Re: FW: FW: Comparison of the approved drawing and permit set for 1227 Las Pu...

These are the differences that I found between the approved set and the building permit permit set. Please clarify.

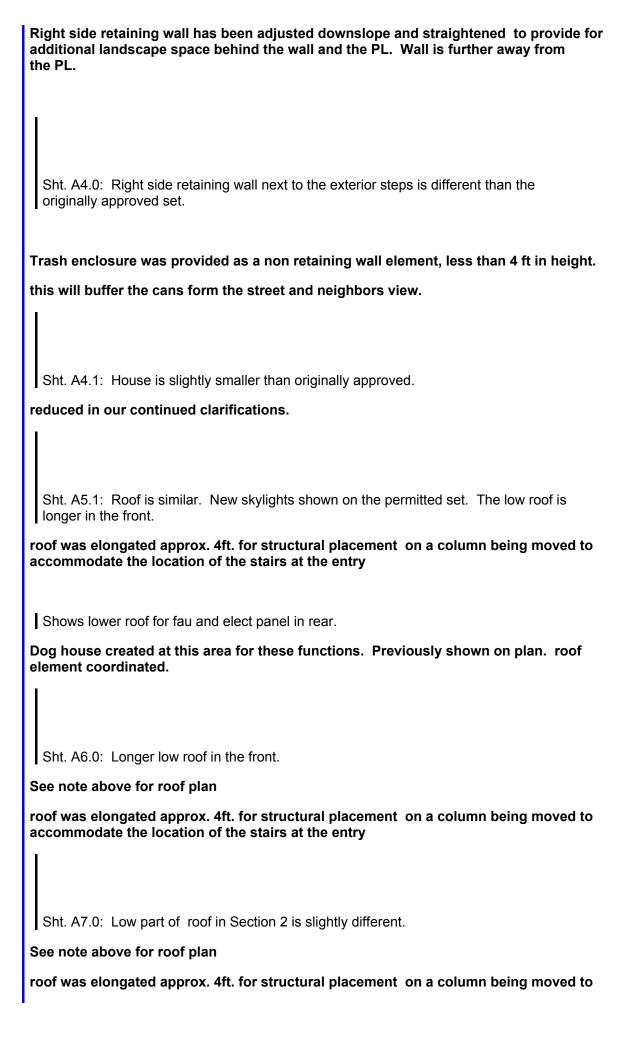
Sht A 2.0: Rear retaining wall is different on the south side.

Right side setback is closer to the right side but is still over a 9 ft. setback.

Retaining wall has been shifted down for a lower overall retaining height. drilling equipment could not extend to this upper reach. Water feature at this area has also been revised.
